TENNESSEE VALLEY AUTHORITY

Docket No. 50-260

This letter is to inform you of a planned shift in the cycle 4 refuel outage shutdown date for the Browns Ferry Nuclear Plant unit 2. The date originally planned for shutdown was March 26, 1982. We now plan to begin the unit 2 cycle 4 refuel outage on August 1, 1982.

ENCLOSURE 7A

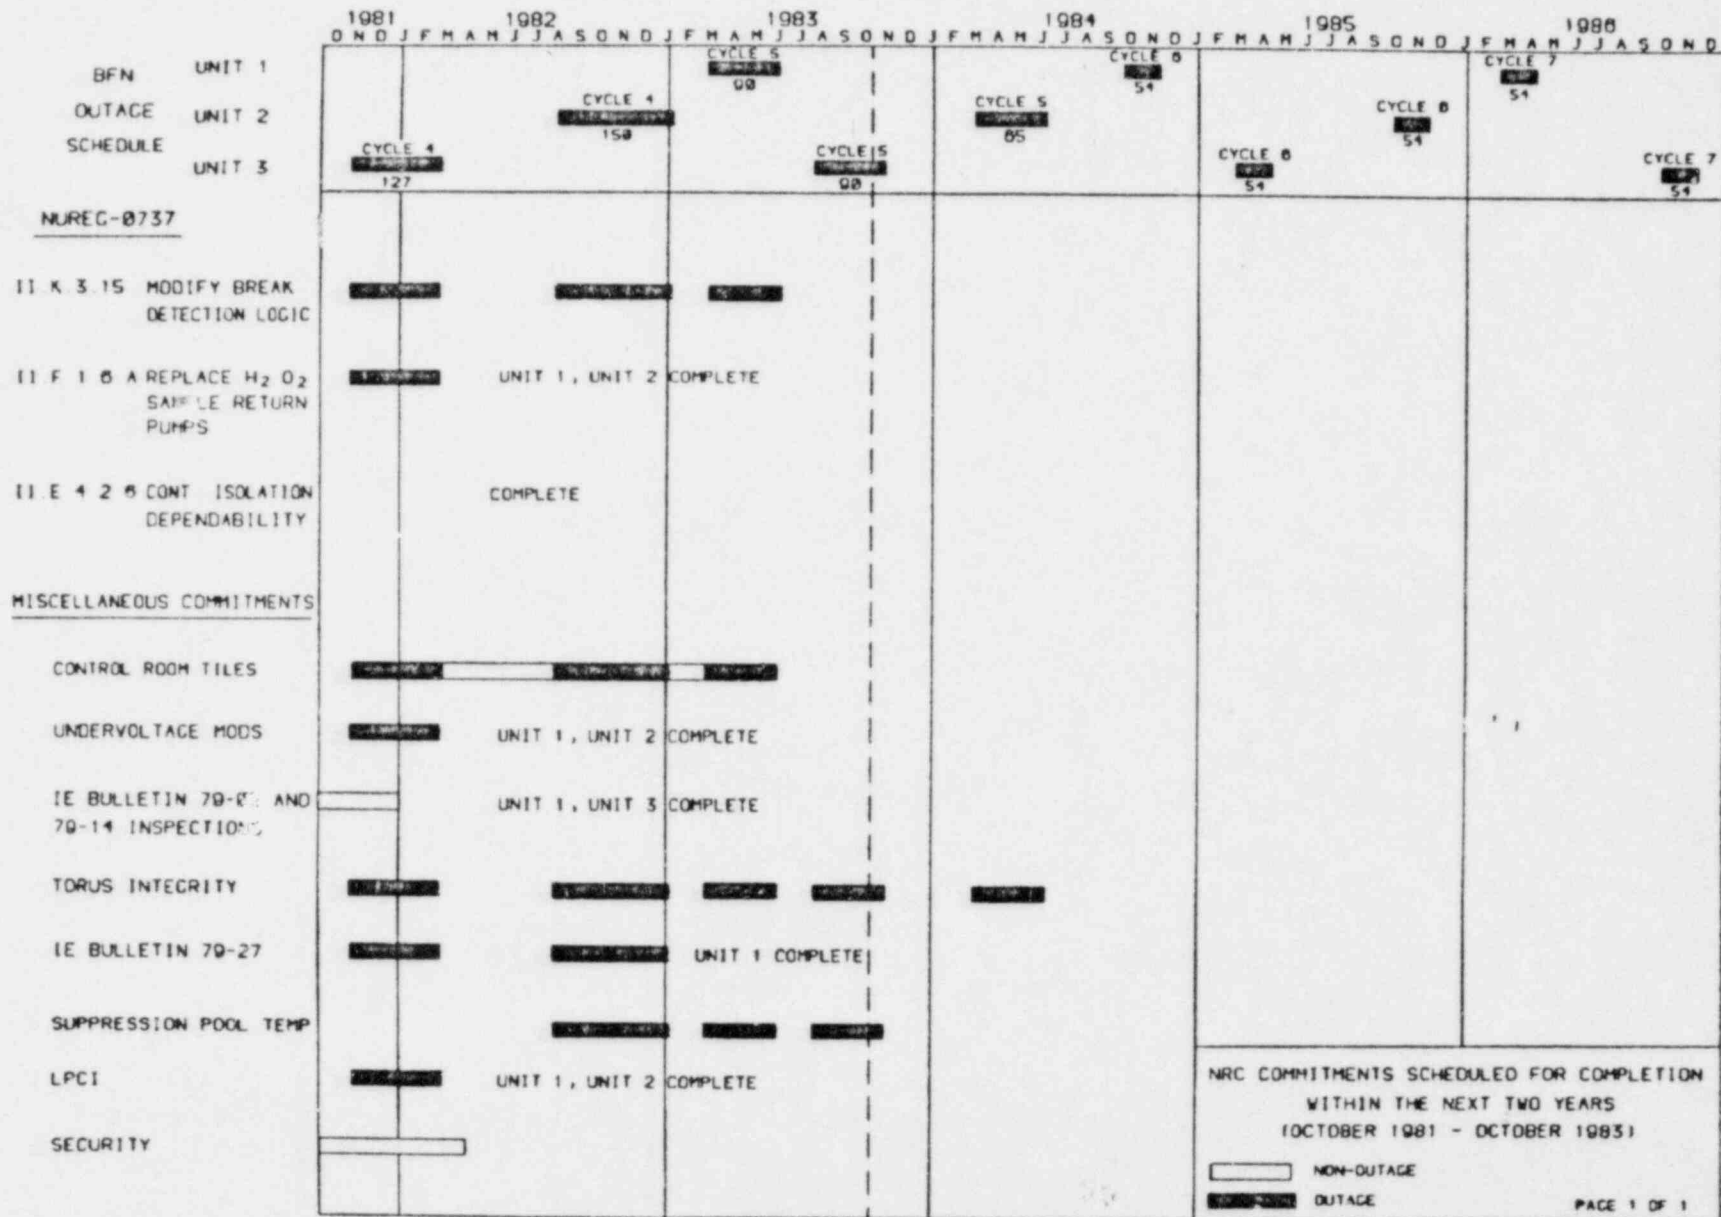
By my letter to you dated October 28, 1981, we submitted the proposed schedule for modifications to be made at the Browns Ferry Nuclear Plant. Enclosures 7A, 7B, and 7C of that letter which presented that schedule showed the unit 2 cycle 4 outage as extending from approximately March to August 1982. Please consider the change to the unit 2 cycle 4 outage identified in your review of the October 28, 1981 letter. We are enclosing revised Enclosures 7A, 7B, and 7C to reflect the new unit 2 cycle 4 outage.
